# Multi Dwelling

Certificate number: 1156801M\_02

| Project summary                            |                                   |  |
|--|-----------------------------------|--|
| Street address                             | 34 Military Road North Bondi 2026 |  |

As requested, this letter has been prepared in relation to the NSW LEC appeal involving Bondi Heights Pty Ltd and Waverley Council (2021/00293527). Amended architectural plans have been prepared by MHN Design Union, dated 16 March 2022, Revision D, which address the Statement of Facts and Contentions, dated 23 November 2021. A summary of the key design changes appears below.

Figure 1: Proposed north elevation

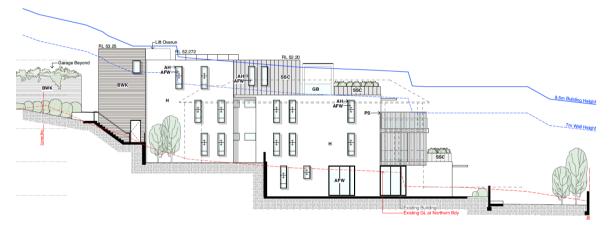
The maximum building height applicable to the site is 9.5m. The amended plans prepared by MHN Design Union have reduced the overall height of the building. The maximum building height was 10.8m on the northern elevation and has now been reduced to 10.2m. The maximum building height on the southern elevation has been reduced from 12.3m to 11m. The extra height reduction is because level 3 was shortened by 3m. Subsequently, the proposed variation will be 1.5m (15.8%). Figures 1 and 2 below show the extent of the variation to the northern and southern walls of the building.

Figure 6: Shadowing on 32 Military Road including reduction compared to Revision B

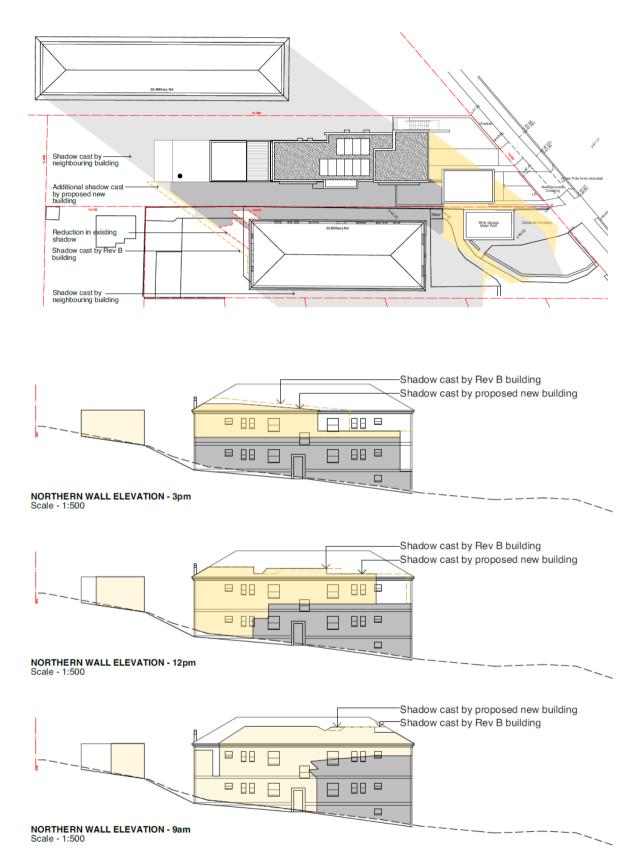
- The proposed height variation does not materially contribute to additional shadowing that would cause any unreasonable overshadowing to the site or adjoining properties. Due to the orientation of the site being situated north of 32 Military Road, the existing three storey dual occupancy and adjoining building at 36 Military Road casts shadows onto 32 Military Road. Furthermore, even a compliant height would generate similar shadowing impacts. Refer to Figures 3-5 showing the existing and proposed shadowing including the reduced shadowing compared to the previously submitted plans. The amended design involving reducing the height reduces shadowing as demonstrated in Figure 6 below.
